New Signal Code and MMI

Version	1.0
Date:	August 1 st , 2022.
Author:	Vegfinans and NPRA
Document	status: Ready for release

Figure 1 – Signal code process diagram flow chart

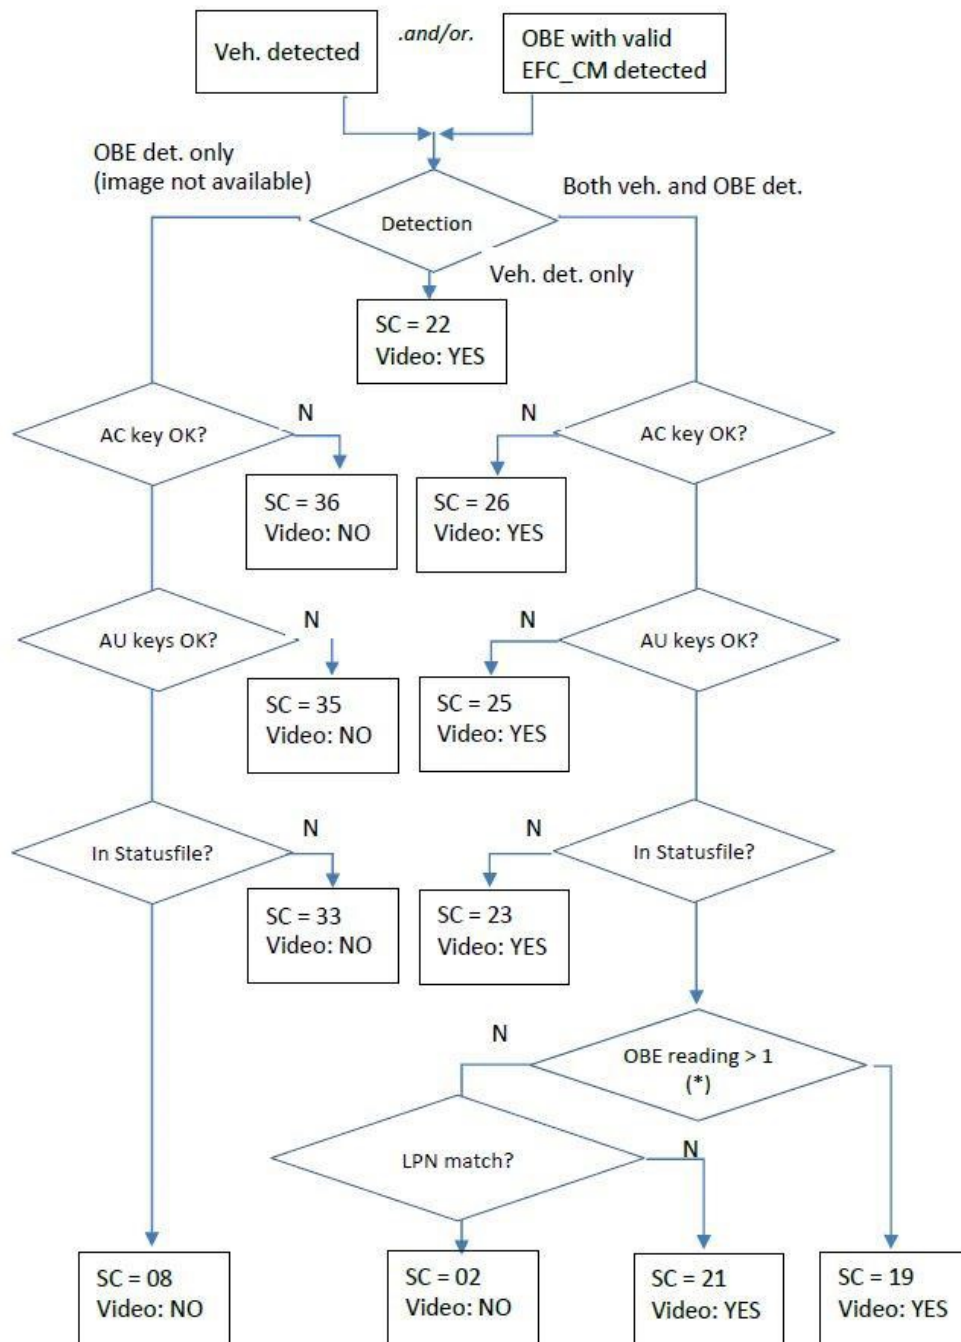
The diagram in Figure 1 shows the different verifications to be done to determine the signal codes and video enforcement of a passage. CPE Supplier should implement logic in CPE that is consistent with this diagram. CPE Suppliers may use different technology in their CPE equipment, especially when it comes to vehicle detection systems. The basic principle in the diagram is that both the OBE reader (antenna) and a vehicle detection system can trigger the processing of a passage. If there is an OBE detection there is normally also an associated vehicle detection, and the rightmost path of the flow chart shows the logic in this situation.

It is assumed in the diagram that only a vehicle detection triggers the video system to capture pictures (front and rear) of the vehicle. In some (often but not necessarily faulty) situations an OBE detection has no corresponding vehicle detection, and pictures are not available. An OBE reading without an associated vehicle detection should be accepted and will undergo the same verifications as if it was a normal OBE passage with both vehicle detection and OBE reading (ref. leftmost path of the flow chart). However, different signal codes will indicate whether pictures are missing.

(*) Explanation of check "OBE reading > 1" in flow chart: Quite often it occurs that there are more than one valid OBE in a vehicle. A basic principle is that there should never be more than one accepted "normal" OBE passage (with SC02) when there are more than one valid OBE in a vehicle. Therefore, it is checked whether the same vehicle detection is likely to also be related to a previously processed and accepted OBE reading. In this case subsequent accepted OBE readings will be assigned a special signal code SC19. If such OBE readings are not accepted, they may be assigned signal codes as eg. SC23. To avoid possible multiple charge of the passage the post processing of the passages in AutoPASS IP must then check the detection counter ("SeqEntryDetection") in the transaction record and discard transactions that have the same value in this field.
